Date: 20 May 2021
Your Ref: NYM/2020/1018/FL
Our Ref: 006/2020/02

PROPOSED REVISIONS: Full/detailed planning for a 150 space visitor car park, vehicular bridge, and other ancillary infrastructure (pay stations, electric vehicle charging points, CCTV poles and cycle stands/storage) and a small section of pedestrian route/footpath on 0.59 hectares (1.47 acres) of land on the former timber yard, East Row, Sandsend (Planning Application Ref: NYM/2020/1018/FL)

Report title:	Designers Response to Stage 1 RSA
Date:	May 2021
Document reference and revision:	11613-004-01
Prepared by:	Sanderson Associates (Consulting Engineers) Ltd
On behalf of:	The Mulgrave Estate

Scale	1:200 @ A2	Drawn By	LOB
Drawing Size	A2	Checked By	IEL
Date	Dec 2020	Approved By	IEL
Drawing Number	11613/003	Rev	A

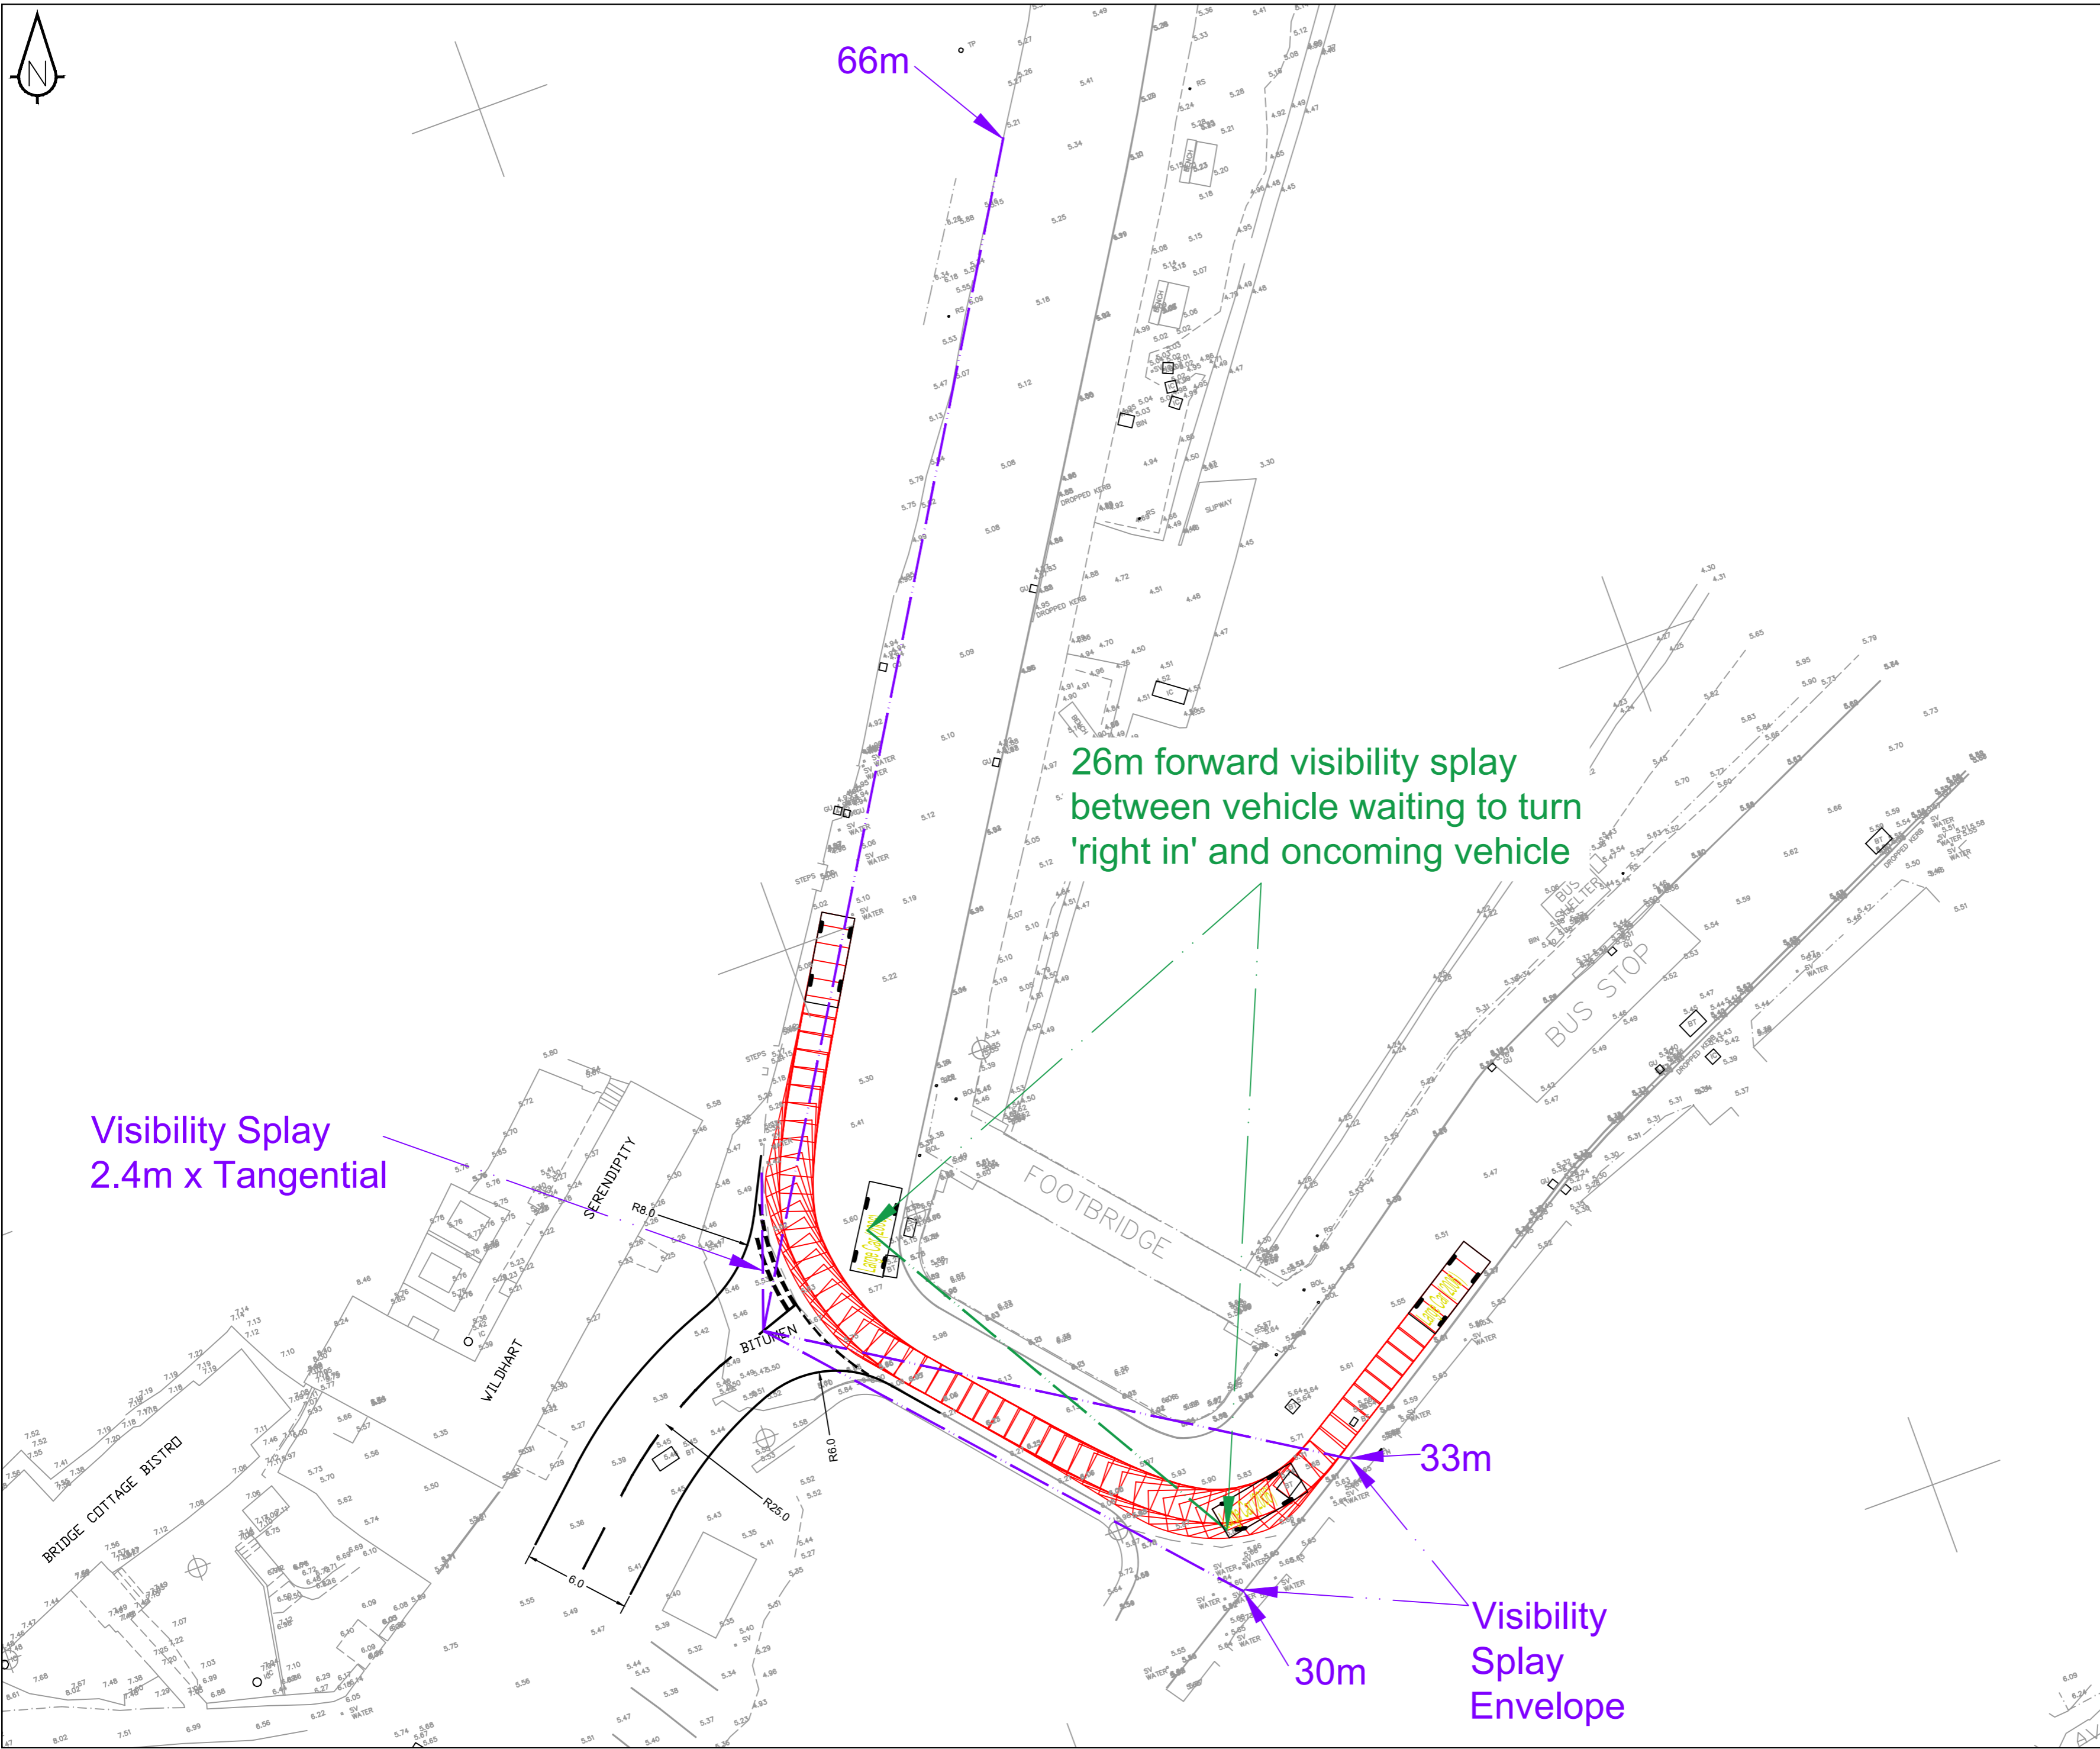
- 4.4 Drawing 11613-003 Rev A at **Appendix F** shows that a forward visibility splay of ~26m is available between a vehicle waiting to turn right into the access (positioned to allow two-way flow to be maintained) and an oncoming vehicle. It is therefore considered that sufficient forward visibility exists for vehicles turning right in to the site.

26m forward visibility splay between vehicle waiting to turn 'right in' and oncoming vehicle

TITLE	SCALE	SANDSEND EAST BECK DEVELOPMENT
MASTERPLAN	1:1000 @ A1	
NUMBER	DATE	FRANCIS ROBERTS ARCHITECTS 1 RIBBLESDALE PLACE, PRESTON PR1 3NA T 01772562221 E architects@francisroberts.com
EBSK 19 rev A	11/05/2021	
	DRAWN	
	DDR & DK

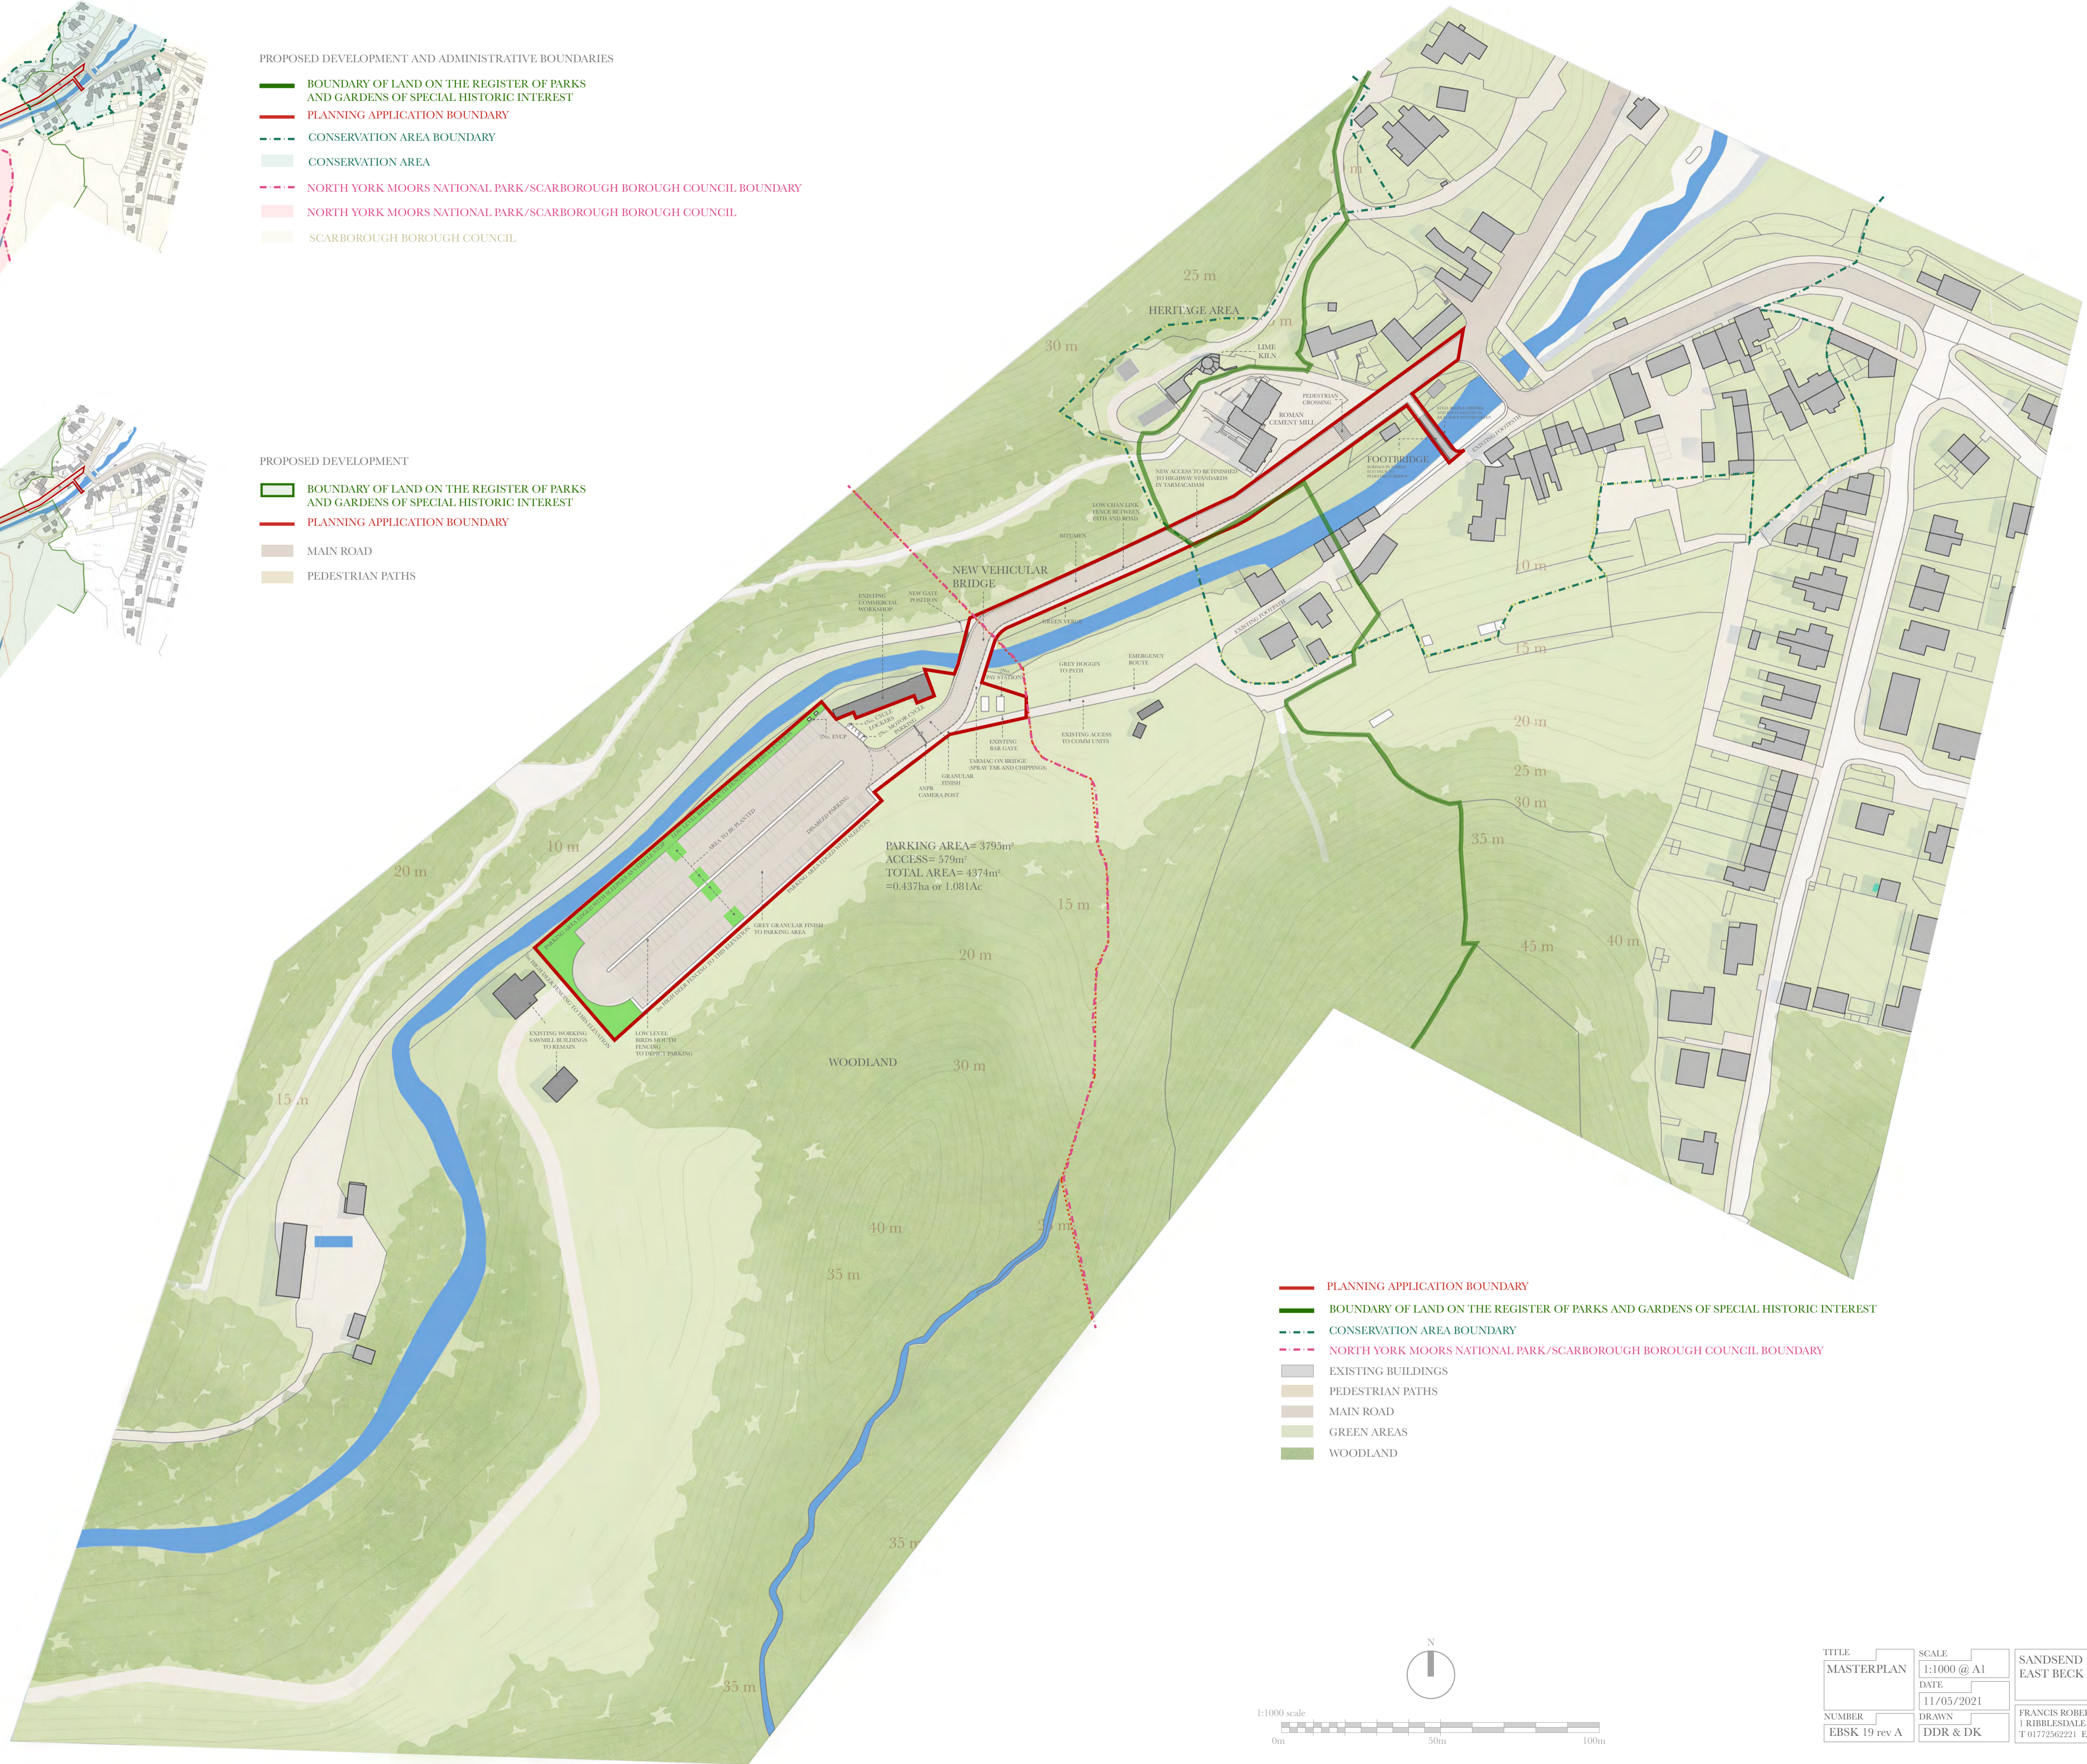
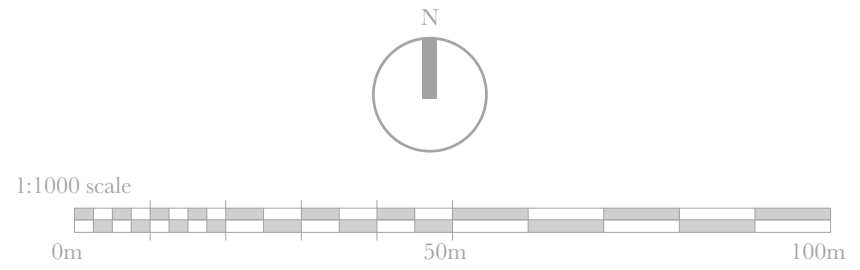
The revisions are proposed to address concerns raised by the Highway Authority in respect of potential pedestrian and vehicular conflicts at the proposed car park access on the north side of the A174 Road Bridge. The revisions also address comments from some local residents in Scarborough Borough Council's administrative area concerned about increased pedestrian activity on the western part of the private road/public footpath on the south side of the beck.

- the relocation of the footbridge closer to the A174 road bridge (in Scarborough Borough Council's administrative area);
- the removal of the formal pedestrian route linking the car park with the private road on the south side of the beck (part in NYMNP Authority area and part in Scarborough Borough Council's administration area) and its replacement with a segregated footway adjacent to the main vehicular access from the car park to the relocated pedestrian footbridge on the north side of the beck (part in NYMNP Authority area and part in Scarborough Borough Council's administration area);
- the relocation of the pay stations to the eastern side of the main vehicular access adjacent to the footway (in NYMNP area); and
- pedestrian improvements at the section of private road from the footbridge to the existing footway on the A174 south of the Beck (in Scarborough Borough Council's area).

5.1 With reference to the revised site masterplan (Ref: EBSK 19 Rev A East Beck Masterplan) included at **Appendix G**, this section of the report provides an audit of the revised pedestrian route proposals between the proposed car park and existing pedestrian infrastructure on the A174. The route will be considered in stages and will provide detail on signage, surfacing and protection as well as other relevant matters.
